**Re: 45 Grenoble Drive Response to Transportation Comments**  
**City File#: 24 253098 NNY 16 OZ**  
**Project No.: 300058194.0000**

R.J. Burnside & Associates Limited (Burnside) has reviewed the City of Toronto (the City) transportation related comments within the following documents:

VEHICLE MANEUVERING ANALYSIS  
P1 FLOOR PLAN

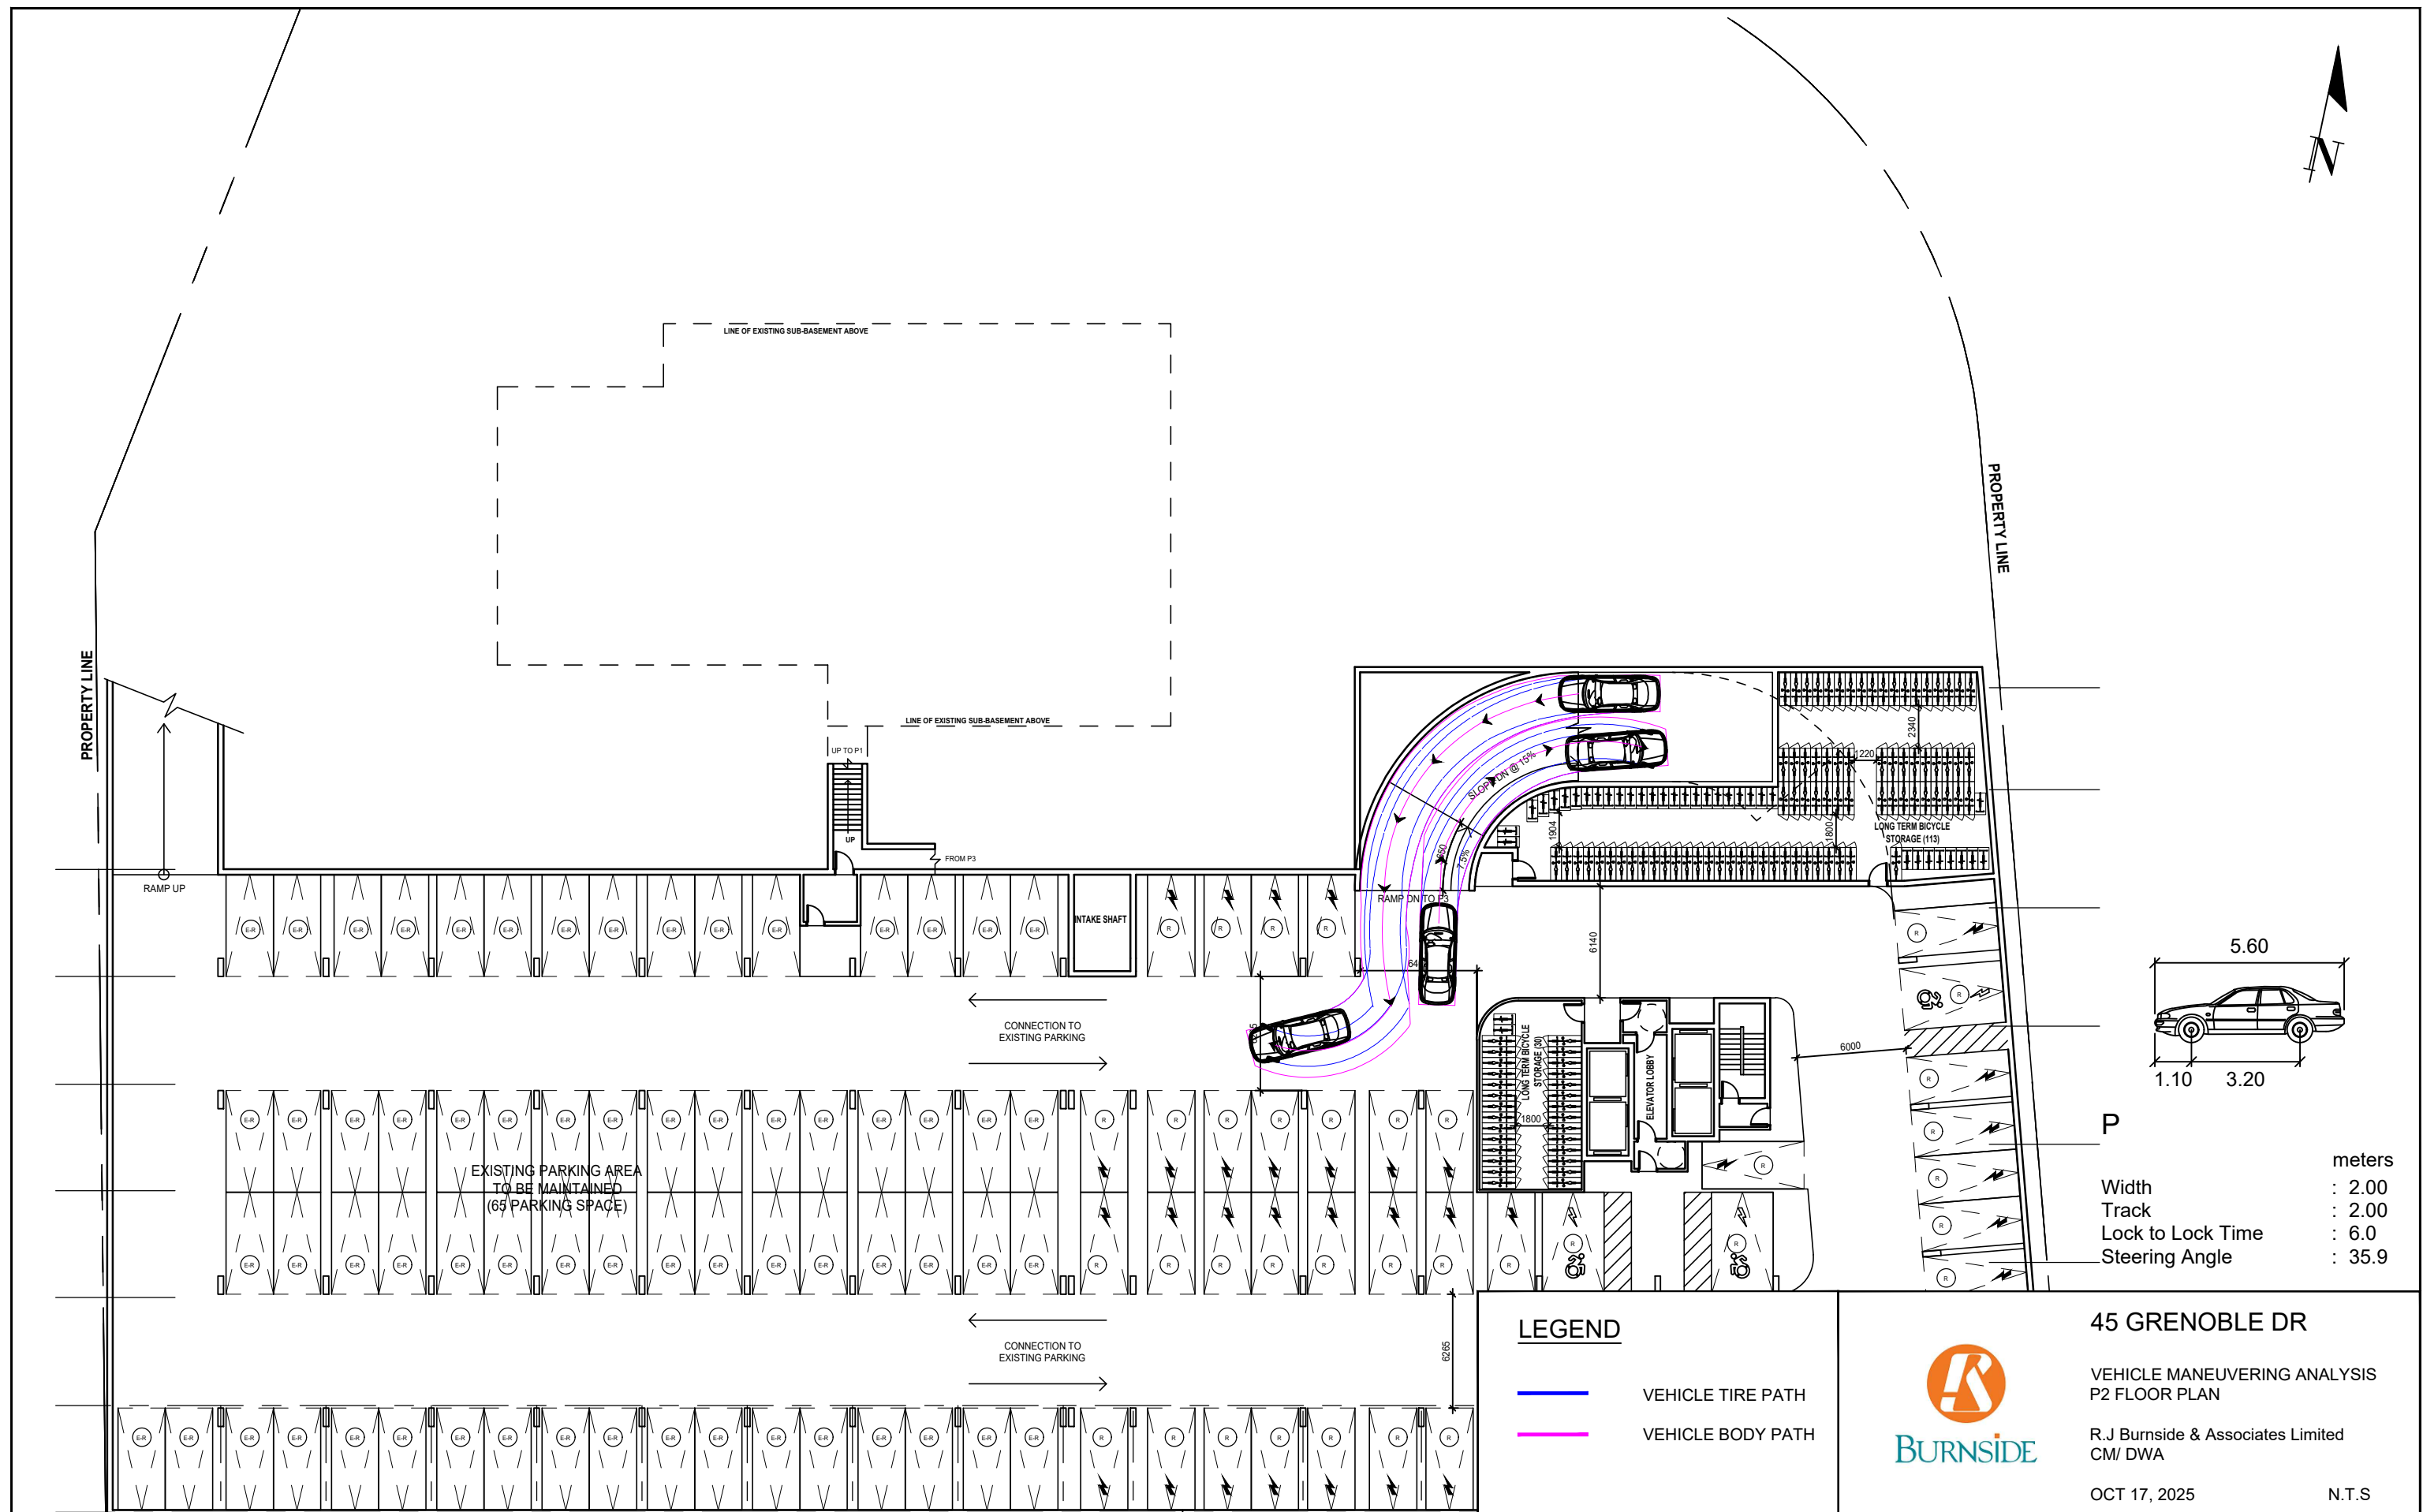
*Provide updated Vehicle Maneuvering Diagrams (VMD) demonstrating heavy vehicles entering and exiting the proposed loading facilities in a forward motion via a consolidated 6.0-meter-wide two-way access driveway onto Grenoble Drive.*

A vehicle maneuvering analysis was conducted in Appendix I of the TIS, which demonstrated the City's front-load and oversized rear-packer refuse trucks can access the existing loading space. A Type C loading space is proposed adjacent to the proposed tower and will accommodate a TAC LSU design vehicle, as shown in Attachment 3.

### Cycle Tracks Functional Plan

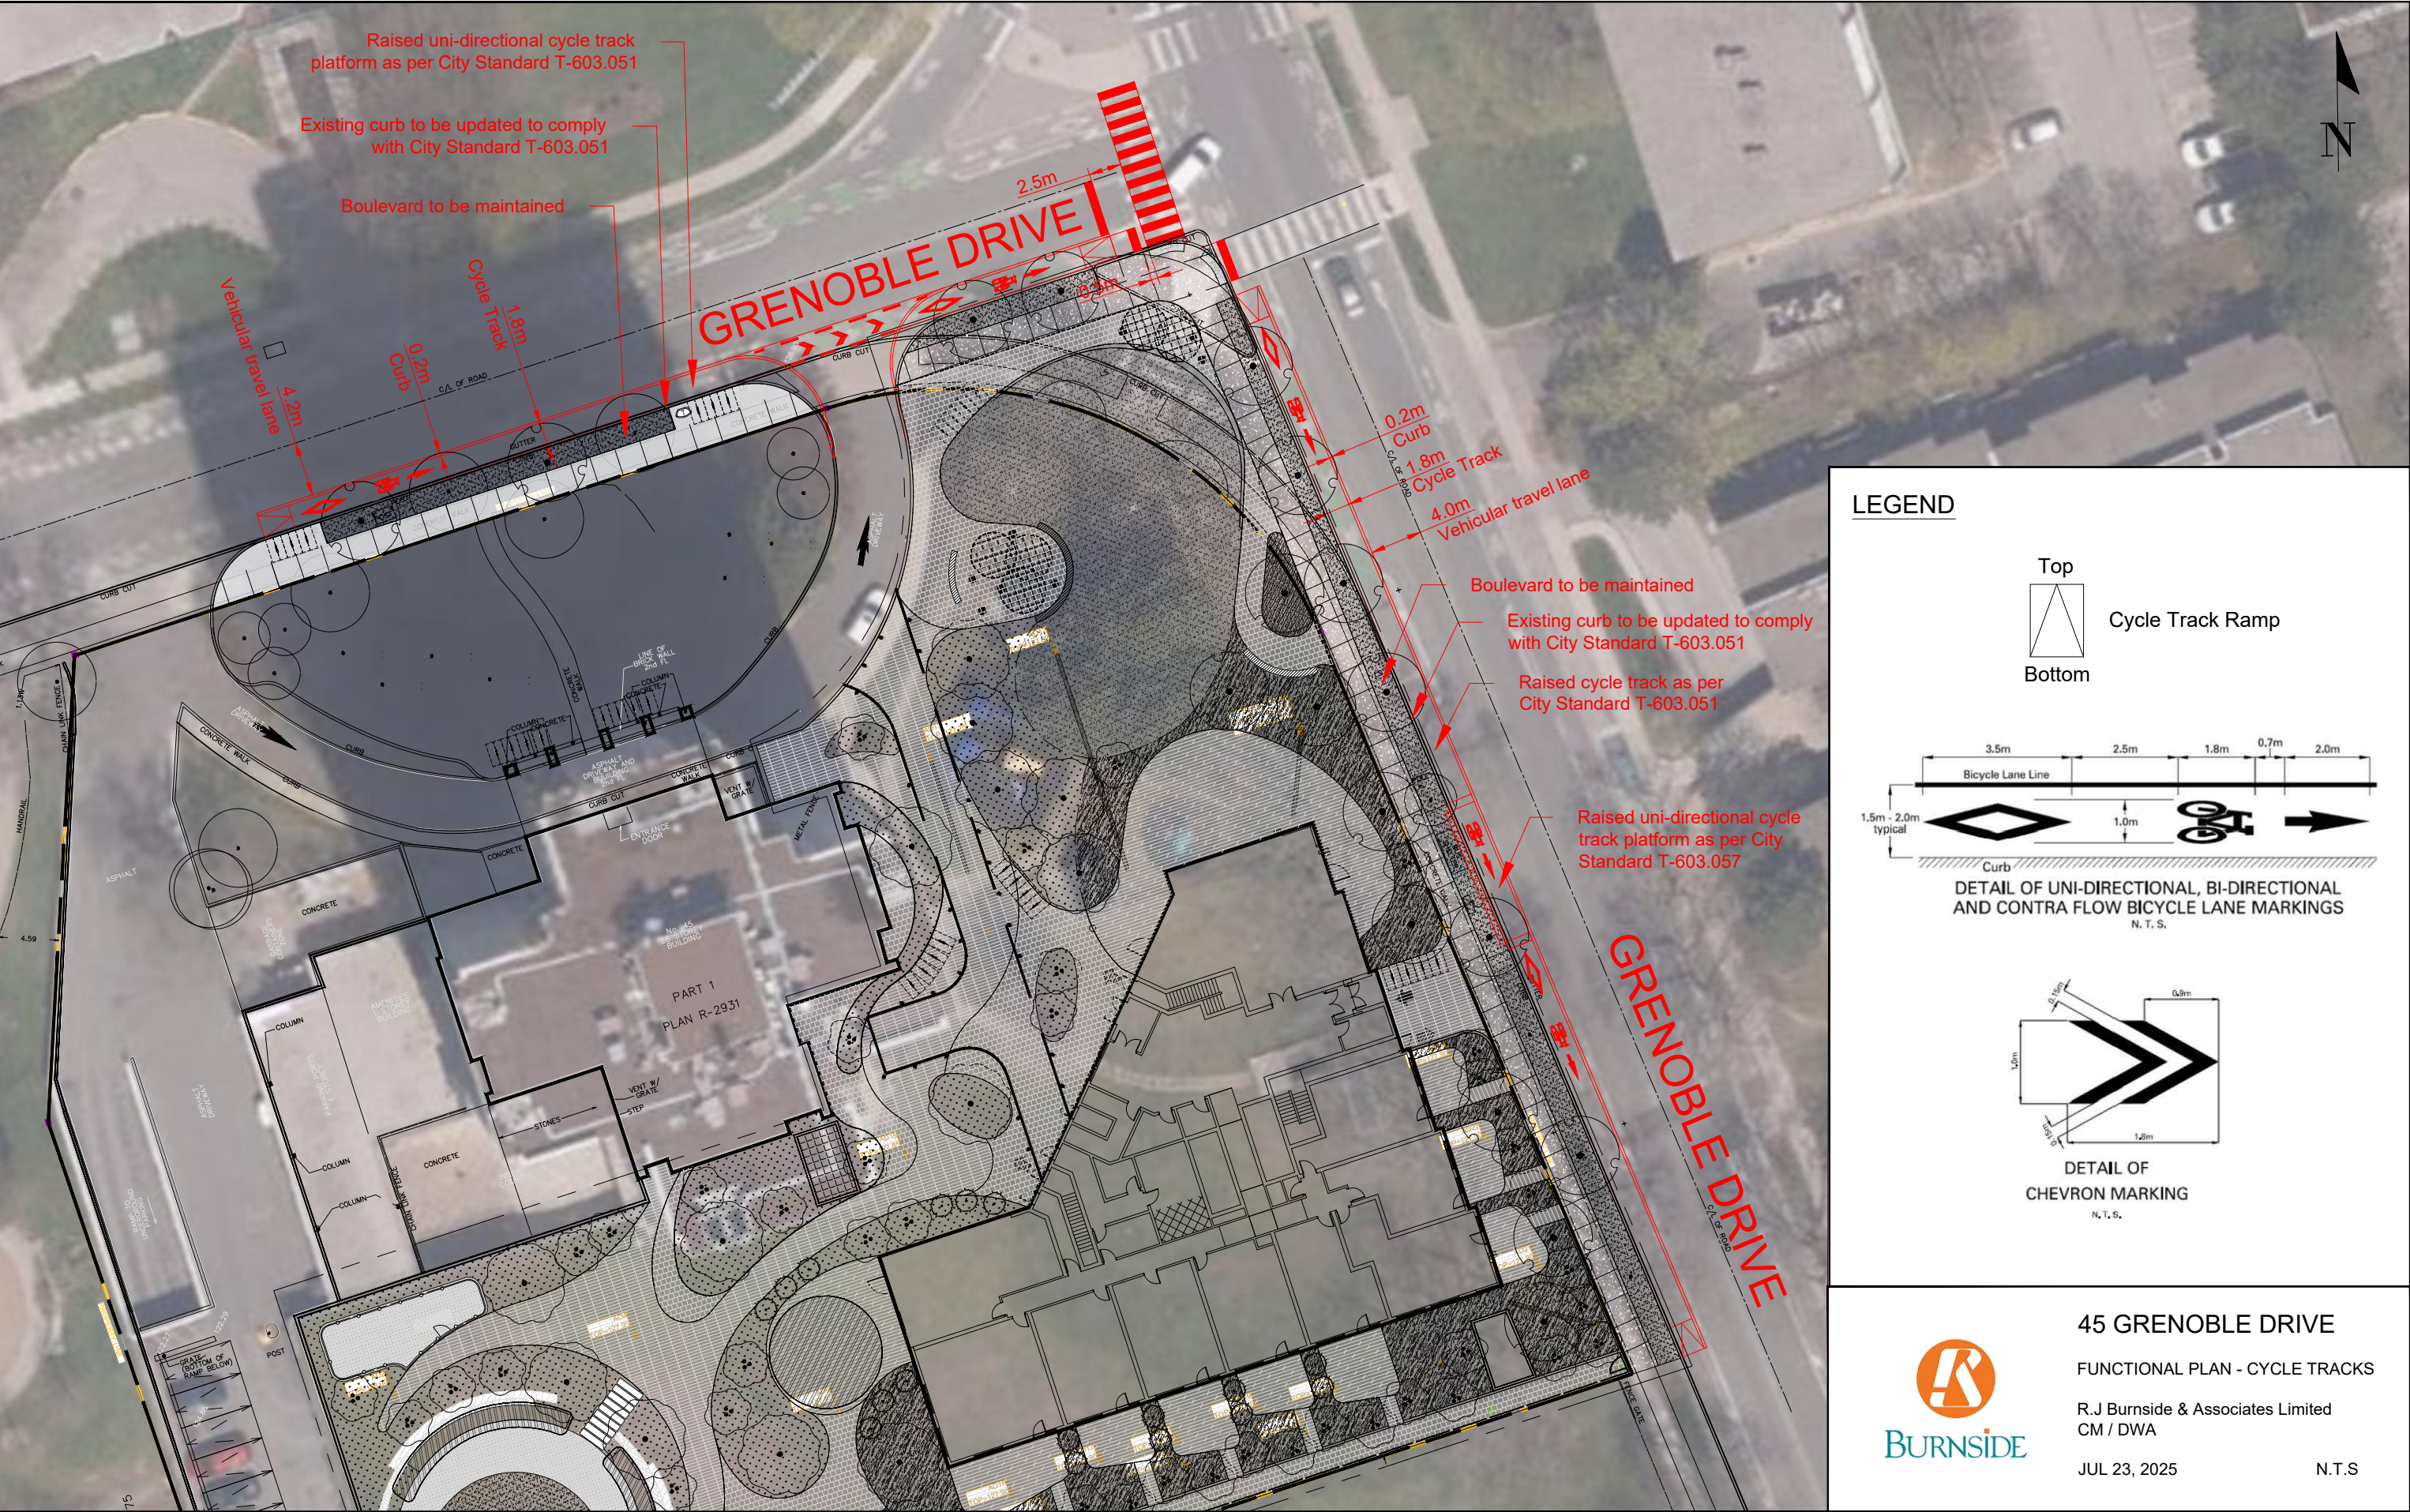
7. *The site frontage on Grenoble Drive is designated as an "On-Street Bikeway". The applicant will be required to secure a clearway area along the site frontage on Grenoble Drive to install cycling infrastructure and cycle track in the future. Please contact Transportation Services for further information;*

8. *The applicant must submit acceptable functional plans (including pavement marking and signage plan) illustrating the modifications to the pavements and signages and road improvements (e.g., On-Street Bikeway) along Grenoble Drive;*

A functional plan for the future cycle tracks was provided for the City's review and comments were received from the City's Cycling Group on July 2, 2025. The functional plan for the future cycle tracks is provided in Attachment 4 and also shown on the updated site plan and is in compliance with City requirements.
